Access Compliance Report Public Rights-of-Way (Curb Ramps)

Main Street: DUNAS_RD Cross Street: CASSELLE_AVE Location: NE

ADA ID: RPAT211005095629 Ramp Type: Type 1 - Perpendicular Diagonal Initial Pass/Fail: Pass Overall Compliance: No Severity Score: 20

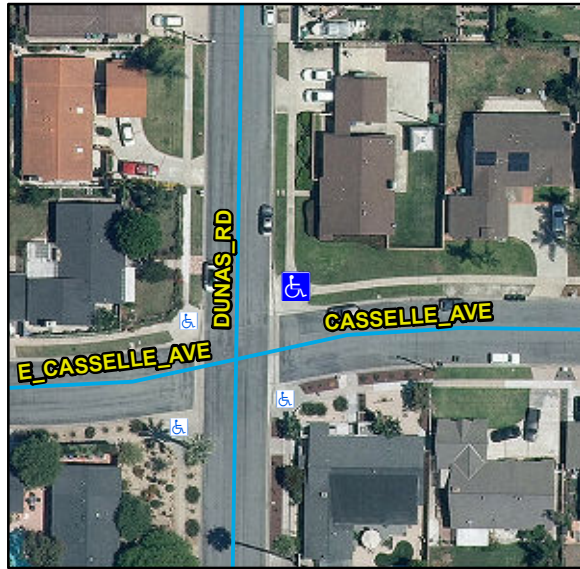
R304.2.2, R204.3, R304.2.1, R304.2.2-Perp, R304.3.2-Para, R304.5.3, R305, STD 1115

Remove & Replace Curb Ramp With Two New Directional Ramps or Equivalent.
